RANKIN INLET TANK FARM LINING AS-BLIET

RANKIN INLET TANK FARM

Construction Summary of Rankin Inlet Itivia Laydown Area Culvert

Request for Information

**RFI No: 012**

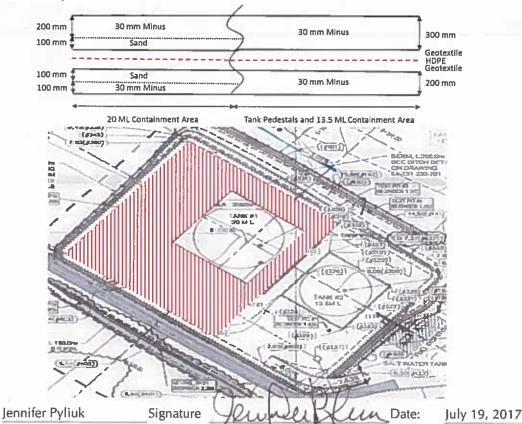
Currently, all under liner material has been placed to design grade throughout the entire containment area, including both tank pedestals. Due to contractor concerns regarding trafficking of the 50t crane to be used for tank erection on the liner system as currently designed and the potential for damage to occur, the liner system has presently been installed on the tank pedestals only, with the intent of completing the liner installation process following tank erection. However, time and schedule constraints have dictated that erection and filling of the 13.5 ML tank at the Rankin Inlet Fuel Farm will be completed in 2017, while erection and filling of the 20 ML tank will be completed in 2018. Therefore, in order to complete the containment facility to remain in regulatory compliance after the 13.5 ML tank is filled in 2017 and still be able to complete erection of the 20 ML tank in 2018, the following design revisions are requested:

- 1. Substitution of 30 mm minus with sand, 100 mm both under and over the liner system (see detail below)
- 2. The above substitution will apply only within the 20 ML tank containment area (excluding the 20 ML tank pedestal) (see detail below)

3. TECHNICAL RESPONSE FROM ENGINEERING AND/OR VALIDATION OF PROPOSED SOLUTION:								
	ptable. However, to prevent migr rial interface both above and und	ation of fine particles, the geotextile ler the liner.	should be placed at the sand					
Engineering	: DOSÉE ALARIE	Signature: Joseo Alame	Date: JULY, 20 301;					
4. If NOT TECHNICAL RFI	VALIDATION OF PROPOSED SOLUTION	N BY SITE SUPERVISION						
		iře						
¥								
		Deviation Request: No	Yes					
	Name	Signature	Date					
Superintendent:								
c.c. Contract Administrator:
